**To:** Richard Collier, McKim & Creed  
**From:** Brian Chambers, Senior Planner; 910.342.2782  
**CC:** File;  
**Date:** 6/1/2021  
**Re:** Center Point TRC Rev 1

Project Name: Center Point  
Formal TRC Date: 6/03/2021  
Reviewer: Eric Seidel, PE  
Department: Engineering – Plan Review Section

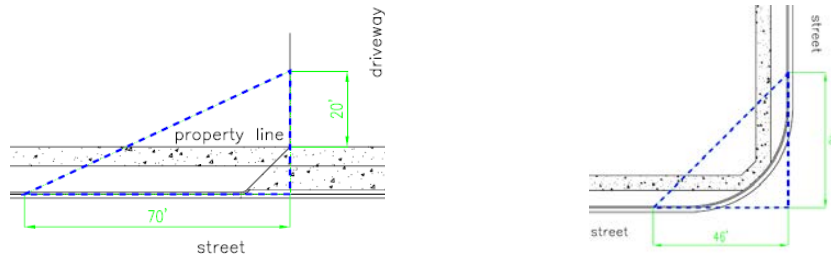
7. Show and apply the City's 20'x70' sight distance triangle at each driveway and the City's 46'x46' sight distance triangle at each street corner intersection on the site plan and landscaping plan. Revise appropriately at relevant locations on all applicable plan sheets. [Sec.18-529(c) (3) CofW LDC] [Sec. 18-812 CofW LDC].
